This Service Information bulletin supersedes SI B51 02 05 **dated February 2007**.

### Squeaking Noise from Door Frame Area While Driving

E60, E61 (5 Series)

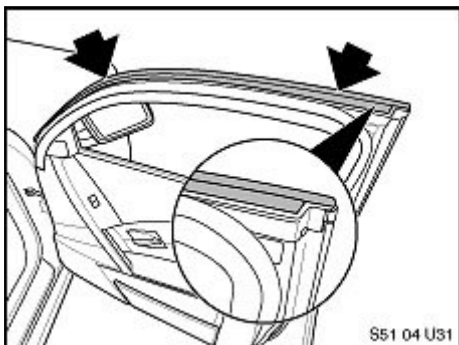
Movement between the flocking material (felt-like material indicated by the arrows) on the upper door seal and the surrounding roof panel may produce squeaking or creaking noises. These noises may be amplified by contamination or cleaner residue on the door opening.

The flocking material was changed in 01/2005 to an improved material with exceptional rigidity, strength, and low moisture absorption.

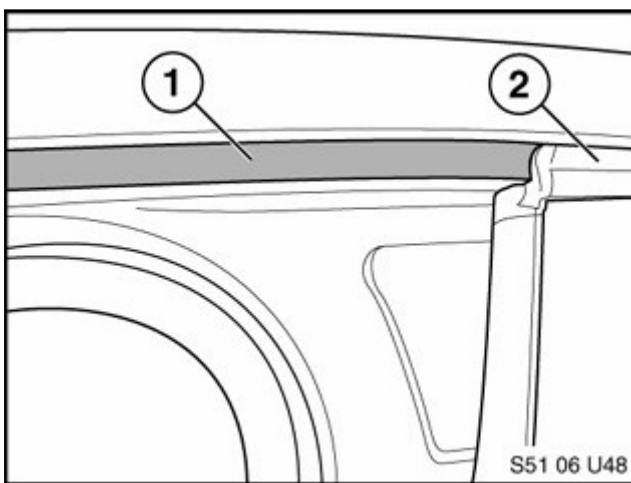
- Apply a continuous length of Teflon tape (PN 9 407 798) to the contact area of the flocking material (1) on the body of the vehicle.
- The area which the tape should be applied to spans from the middle of the A-pillar to the rear-most point on the rear door opening, as indicated by the arrows.

The tape should be applied slowly and very carefully to avoid trapping air bubbles under the tape. To eliminate visibility of the tape when the door is closed and ensure proper contact with the flocking surface, the upper edge of the tape (1) should line up evenly with the top of the door seal (2) for the entire length of the applied area. The tape should be applied in its full width (16mm) and not be cut down to a narrower width.
